To all general contract bidders of record on the Bid Proposal titled:

**Anna & Abby's Yard at Rogers Park**  
**Project No. 2020-1**  
**ADDENDUM #1**  
**Date: March 3, 2020**

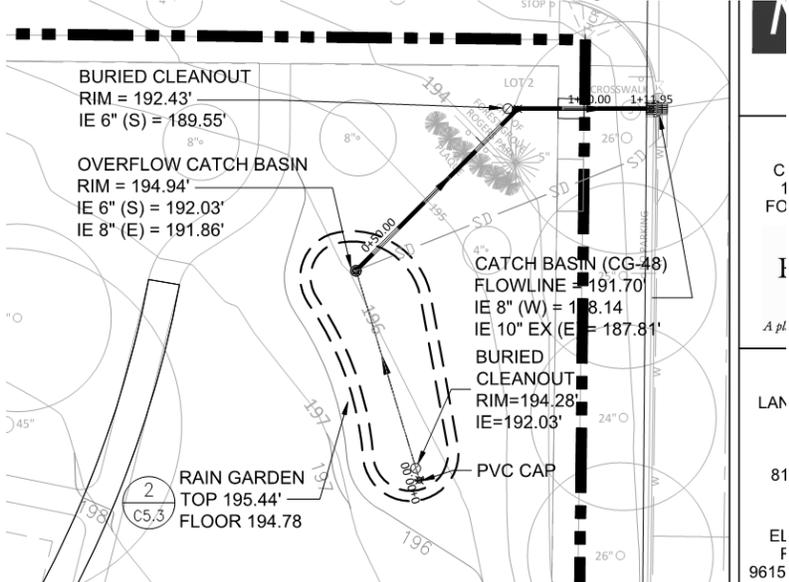
Q1: Please provide more information for how we tie into existing storm system. The drawings are not clear if we are tying into existing CB or demoing the old one and installing a new one...?....the drawings reference a curb inlet detail which doesn't seem relevant if we're tying into the existing.

A1: *The contractor is to remove the existing structure and install a new inlet, Clean Water Services Standard CG-48 (see attached), along the curb line as shown below.*
